155-056-10

## **ADDENDUM NO. 1**

Nebraska Administrative Services - 1526 Building Remodel  
Lincoln, NE  
TCEP Project No.: 156-056-10

Addendum #01  
 Supplemental Drawing: SDM-003  
 Revision of Sheet: M3.1  
 Date: March 23, 2012

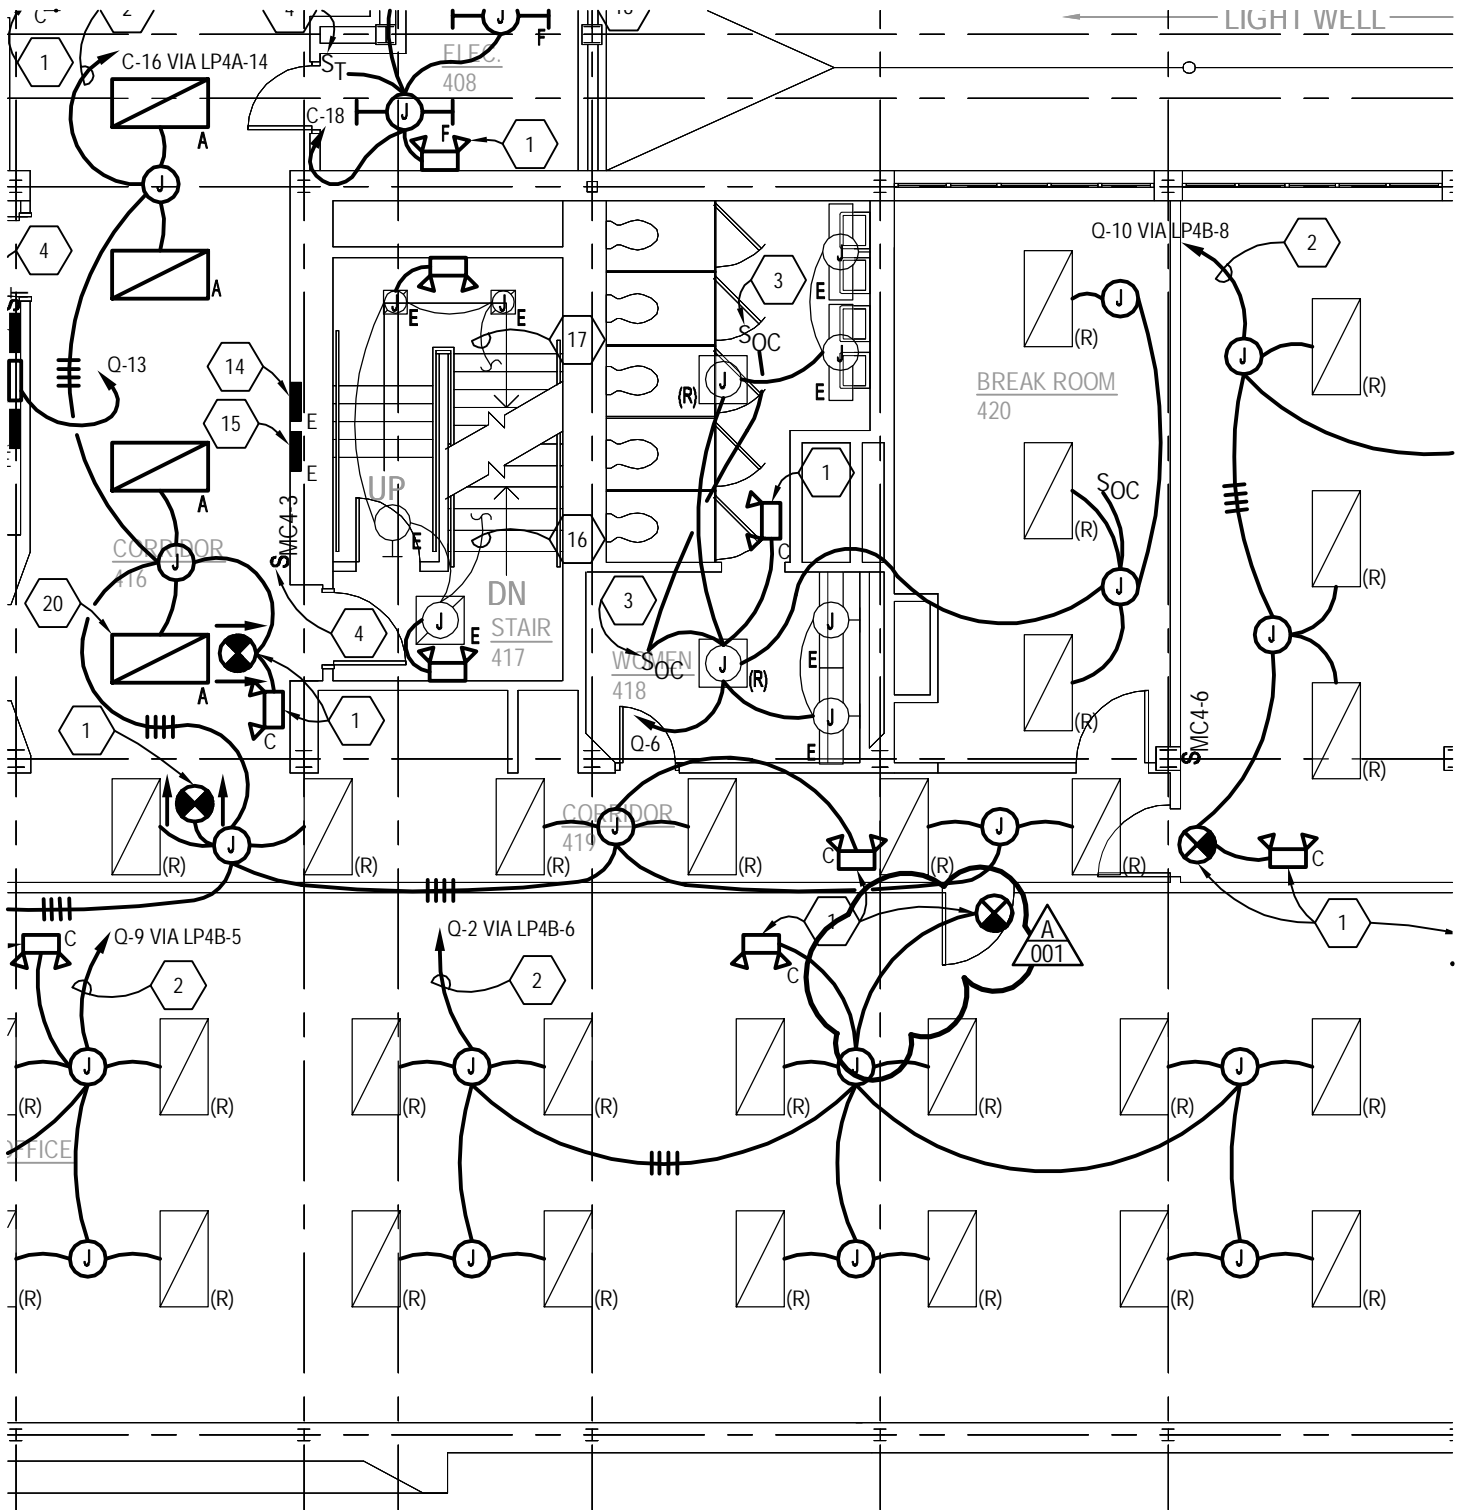
- Under Bid Alternate M-3 provide a new eighteen (18) fan wall as shown on the attached Partial Enlarged Basement Mechanical Room Plans, Supplemental Drawing SDM-003. With this Alternate M-3, the new SF-1 to be a 6 wide x 3 high direct drive fan wall, Hunt Air Fan Wall with each of the eighteen (18) 20” diameter fans with capacity to be 6,666 CFM at 6” WC TSP, 9.06 BHP, 2480 RPM, premium efficiency inverter duty rated 10 HP, 208 volt, 3 phase, 60 Hz. motor. The total fan wall capacity to be 120,000 CFM at 6” WC TSP and total electrical characteristics are FLA= 497 amps, MCA = 505 amps, MOCP=600 amps Provide each fan with factory mounted VFD, line side motor protector and gravity back draft dampers to prevent back flow through the “off” fans. The fan wall to be provided with a control panel with integral electrical single point disconnect, transformer, low voltage control circuit, PLC controller, power distribution panel and associated equipment. Entire fan wall to be controlled by BMS with all 18 fans sequenced by the fan wall control panel to optimize operation with as few fans as close to maximum capacity as necessary to satisfy the 3<sup>rd</sup> and 4<sup>th</sup> floor SA duct main static pressure sensors.

NOTE:  
 FIELD INSTALLED SF-1 ELECTRIC CONTROL PANEL WITH INTEGRAL ELECTRIC DISCONNECT. BMS TO PROVIDE SINGLE ANALOG CONTROL SIGNAL TO ELECTRICAL CONTROL PANEL.
